PRIMERGY CUSTOMER INFORMATION BULLETIN

PY-CIB050-00

Performance Might be Decreased with BIOS R1.29.0 or Newer

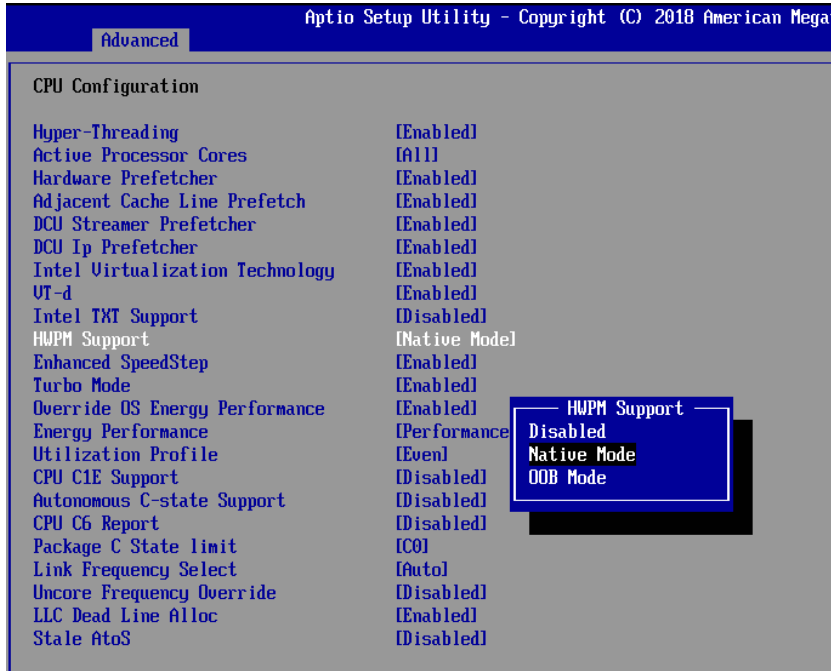
The system performance might be decreased after BIOS R1.29.0 or newer is installed.

With BIOS R1.29.0, a new option for Hardware Power Management (HWPM) in CPU Configuration under the Advanced menu in BIOS was introduced. The current value will be overwritten with the new value ("Native Mode with No Legacy Support").

HWPM Support Options before R1.29.0:

Default value is “Native Mode”.

HWPM Support Options with R1.29.0 or newer:

Default value is “Native Mode with No Legacy Support”.

For Windows Server 2016, 2019, RHEL 7.6 or newer, “Native Mode with No Legacy Support” is the optimal setting. We recommend to check and correct the setting to “Native Mode” in case you are using VMware, Windows Server 2012 R2, or older Linux distribution (for example RHEL 7.4).
